ADDENDUM

**TO PLANS, SPECIFICATIONS AND SPECIAL PROVISIONS FOR
CSAH 5 INTERSECTION IMPROVEMENTS
HENNEPIN COUNTY TRANSPORTATION DEPARTMENT**

ADDENDUM NO. 2

CSAH 5 & 152; C.P. 155401

C.S.A.H. 5/HENNEPIN COUNTY PROJ. 155401 SHEET **S22R**
TRAFFIC SIGNAL SYSTEM INTERSECTION LAYOUT
SYS "A" - E FRANKLIN AVE AND CEDAR AVE **S37**

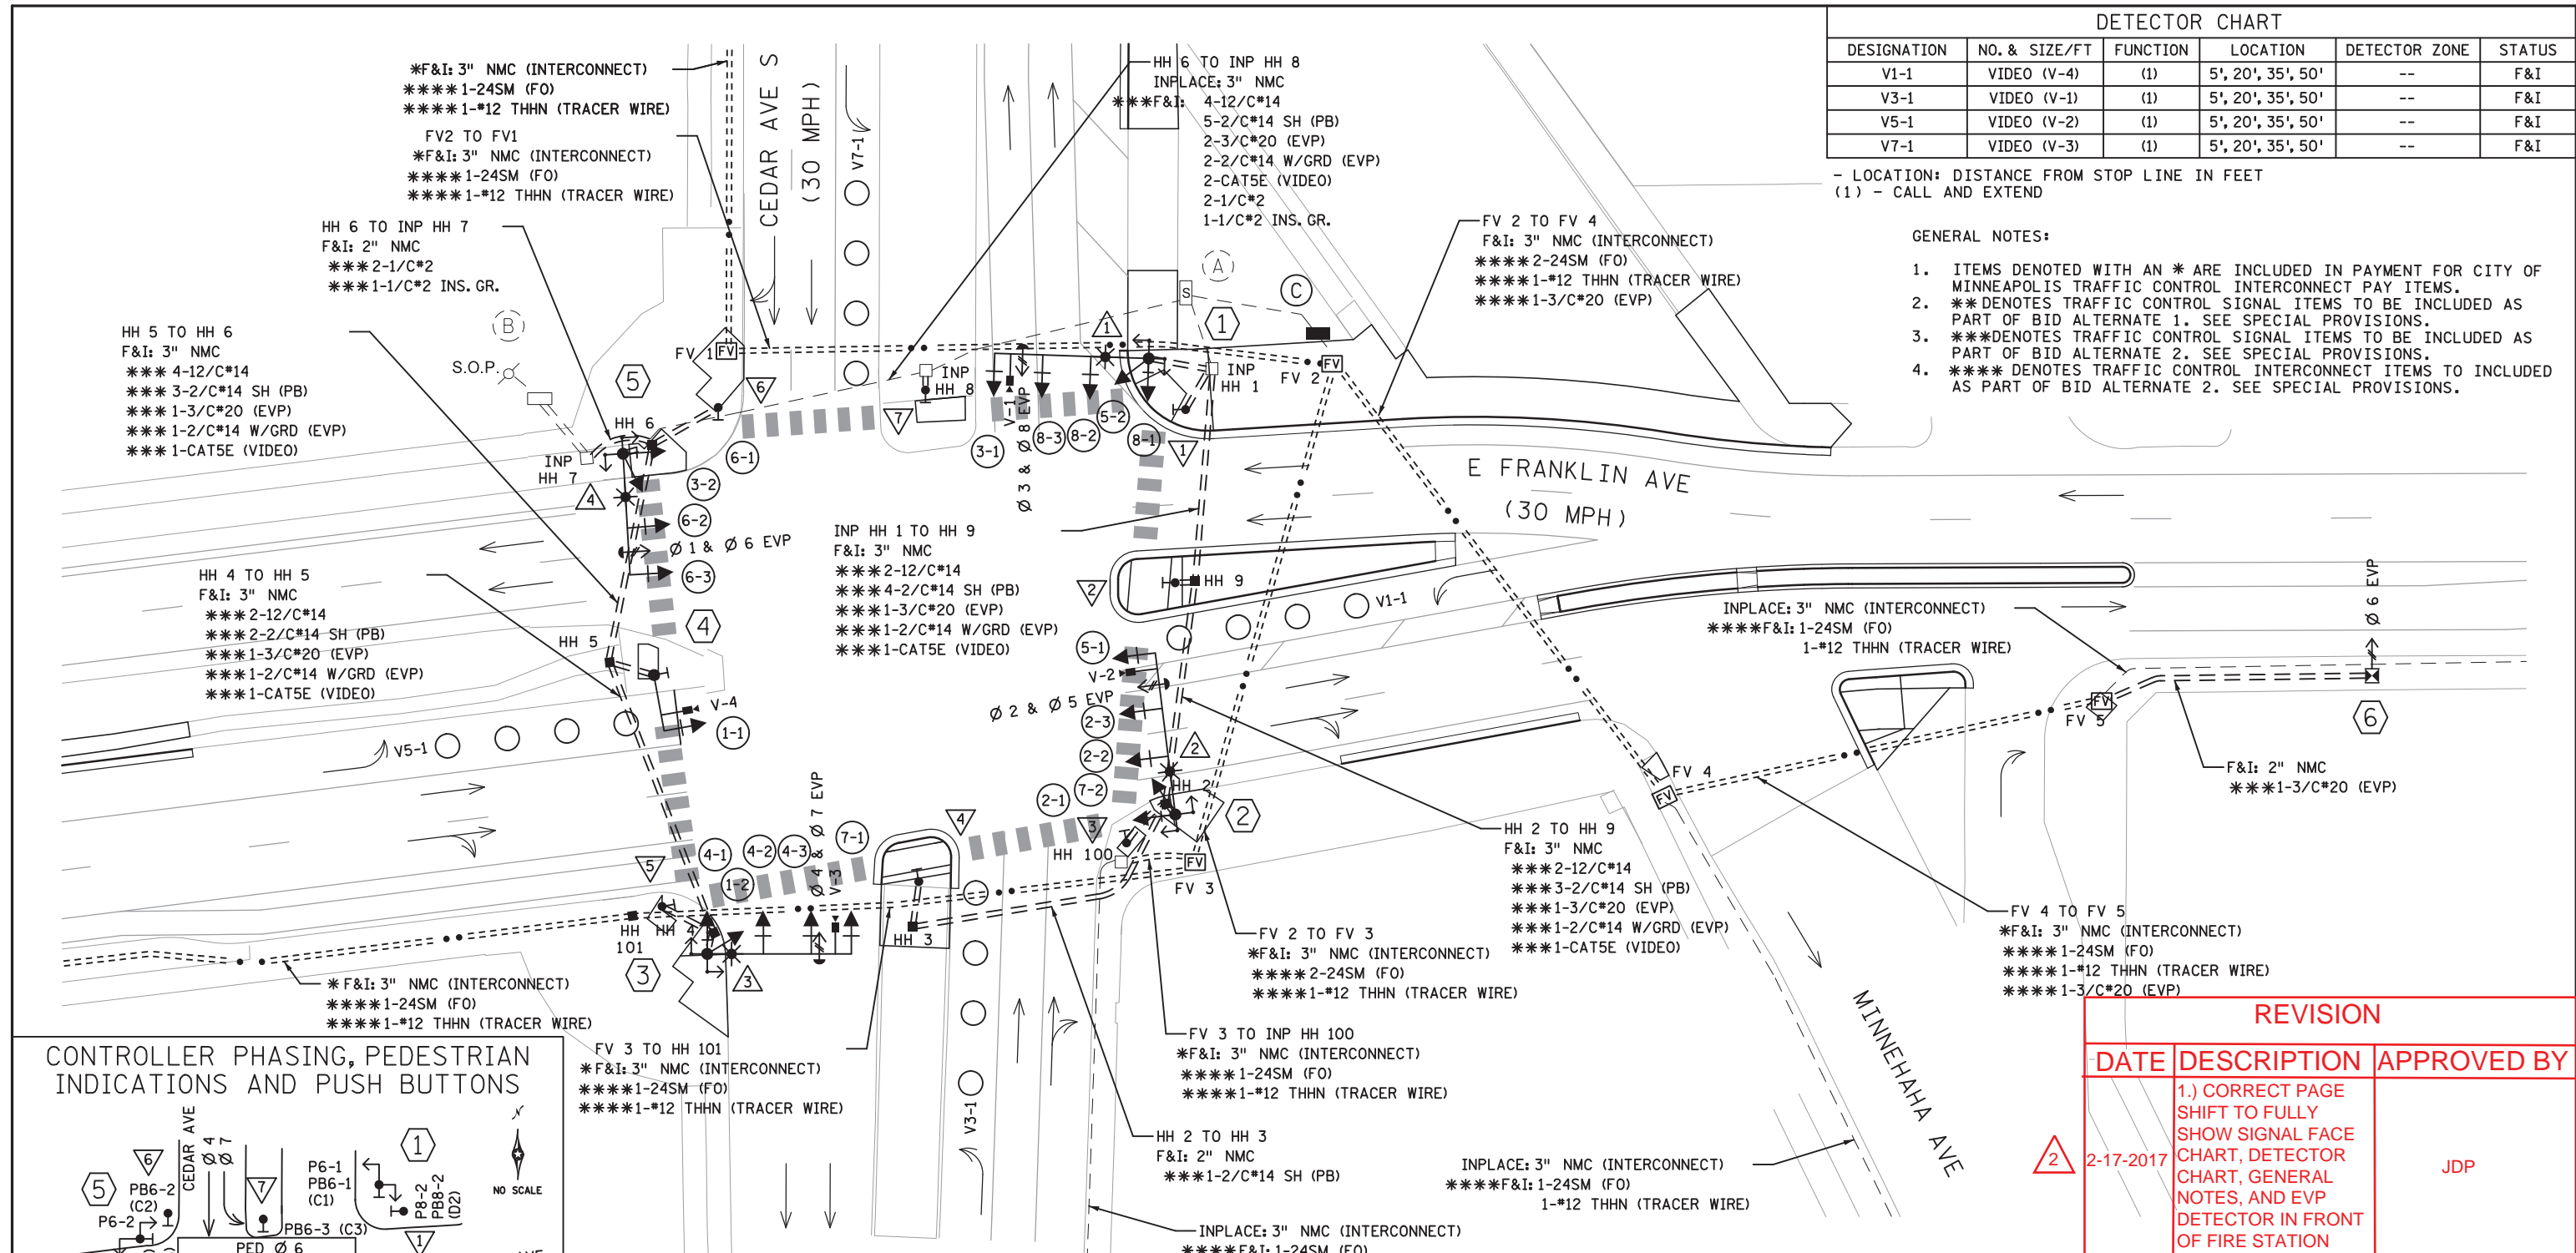
1. Plan Sheet No. S22 TRAFFIC SIGNAL SYSTEM INTERSECTION LAYOUT – **Remove and Replace** with attached Sheet S22R with Last Revision Date 2/17/17.
 - Correct page shift to fully show signal face chart, detector chart, general notes, and EVP detector in front of fire station.

REVISION		
DATE	DESCRIPTION	APPROVED BY
2-17-2017	1.) CORRECT PAGE SHIFT TO FULLY SHOW SIGNAL FACE CHART, DETECTOR CHART, GENERAL NOTES, AND EVP DETECTOR IN FRONT OF FIRE STATION	JDP
